AGENDA

BOARD OF COMMISSIONERS

Monday, November 14, 2016 - 6:30 PM

RE: Academy of Notre Dame de Namur – Preliminary Subdivision Plan
Academy of Notre Dame de Namur – Applicant

SHEET
SP-3
OF 6

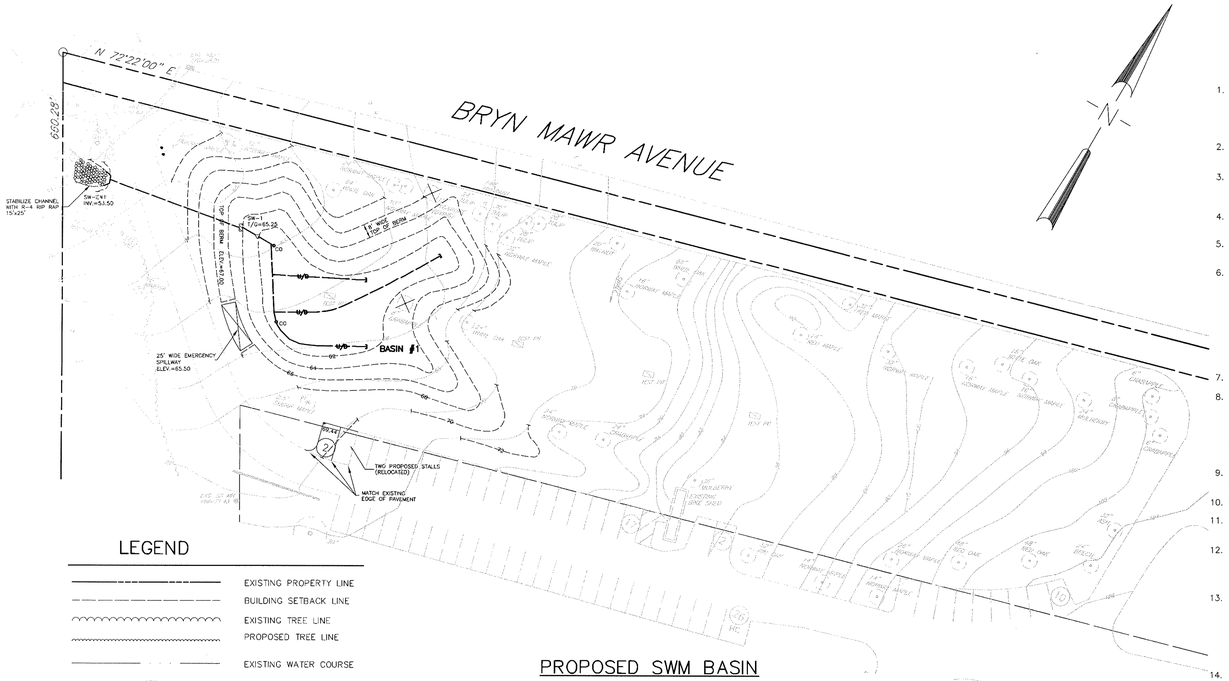
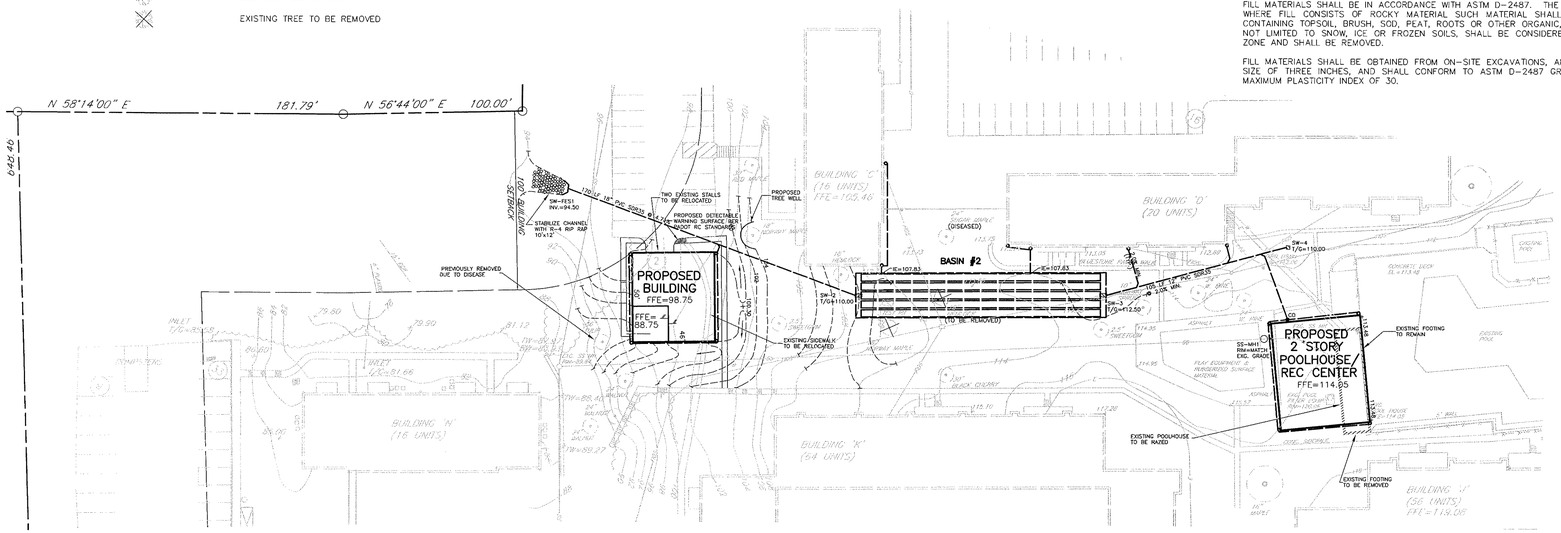
5. Note 15 on Sheet SP-3 stated drainage from Buildings C and K shall go into Basin A. From the plans provided it appears that runoff from Building D and not Building K drains to Basin A. Please provide drainage area plans to clarify.

BASIN #2 DETAIL

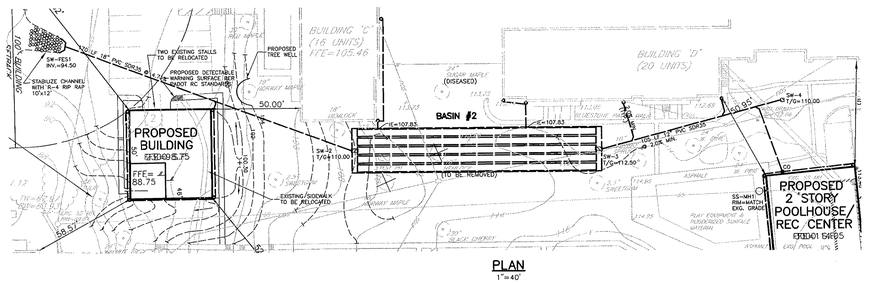
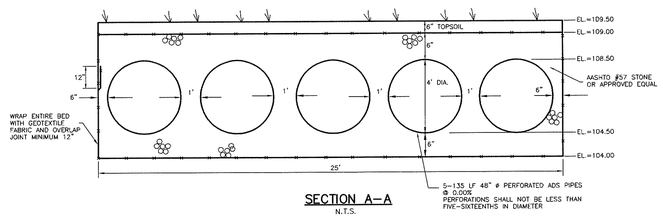
7. Further detail must be provided on the outlet control structure provided for Basin #2. The detail on Sheet SP-6 Additionally, include information in the stormwater report showing that the detail shown on the plan matches the system that was modeled.
